# Technical Service Bulletin

**93 A8 TFSle: coolant connection (quick-release coupling/neck connection) on HV battery leaking**  
93 24 81 2074624/1 July 26, 2024.

Model(s)	Year	VIN Range	Vehicle-Specific Equipment
A8 e quattro	2020	All	Not Applicable

Example photo of A7 PEHV

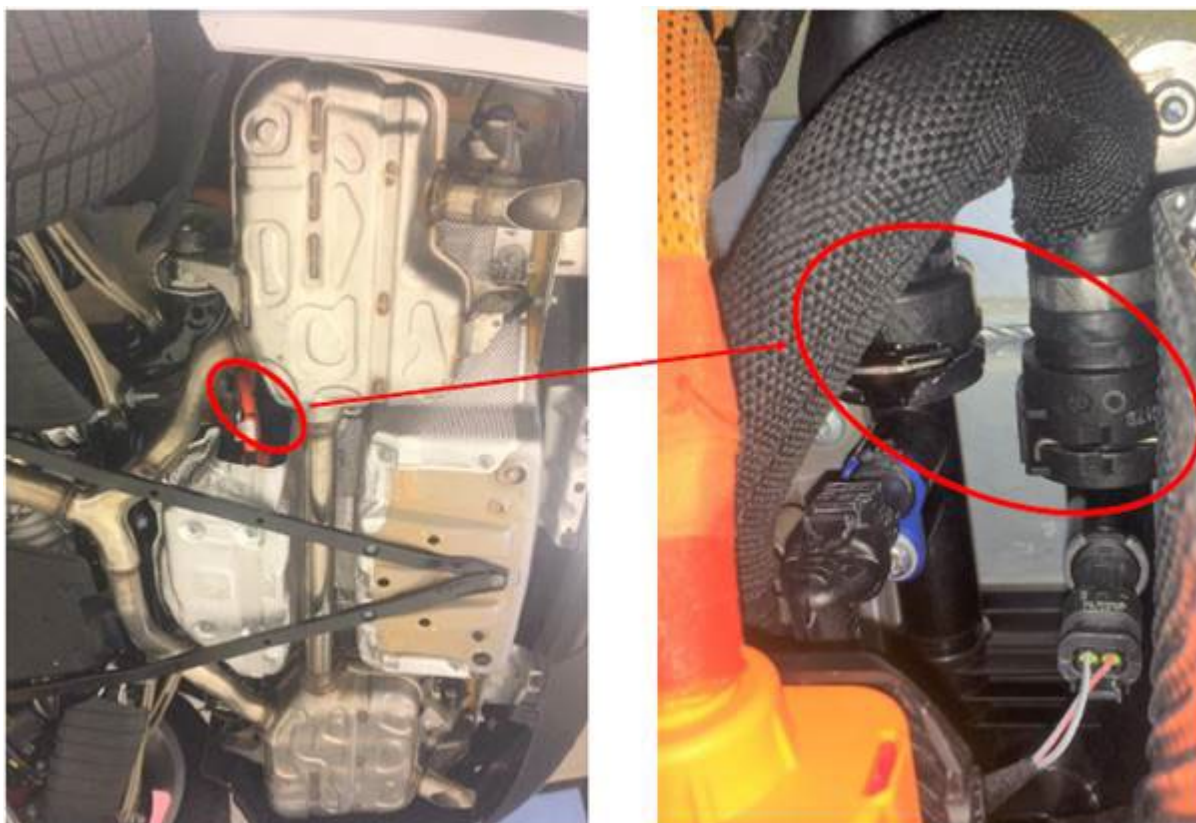
Coolant residues are established in the area of the rear axle on the connections of the high-voltage battery.

The coolant hose connection is outside of the tolerance.

In order to resolve the conflicting tolerance of the coolant hose connection the Y seal ring (WHT.009.067) of the coolant hoses is replaced with an O seal ring (WHT.009.245)
